PRODUCT CHANGE NOTIFICATION

Bourns® Model CRT Series Surface Mount Thin Film Resistors

Additional Overcoat Layer

N2449

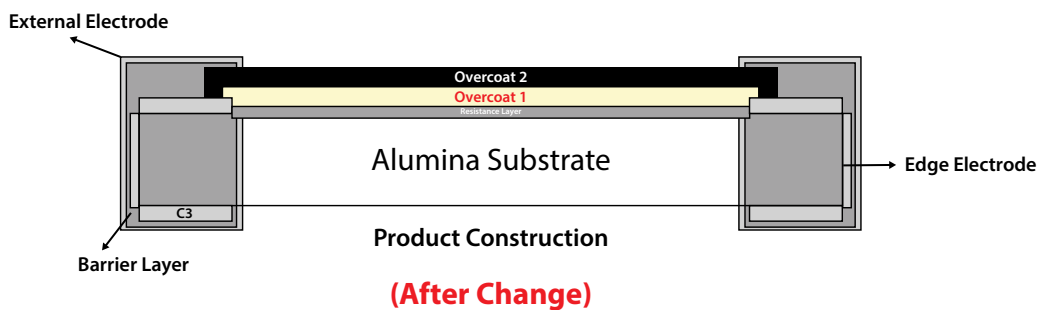
Riverside, California – October 29, 2024 – In the spirit of continuous improvement, effective December 1, 2024, Bourns will add an additional overcoat layer between the resistance and marking layers of the [Model CRT Series Surface Mount Thin Film Resistors](#) to enhance humidity and sulfuration capabilities. A list of affected part numbers is included in the attachment.

Current Resistor Structure

New Resistor Structure

There is no change to the form, fit, function, quality or reliability of the affected part numbers. Traceability will be maintained through the lot code and date code.
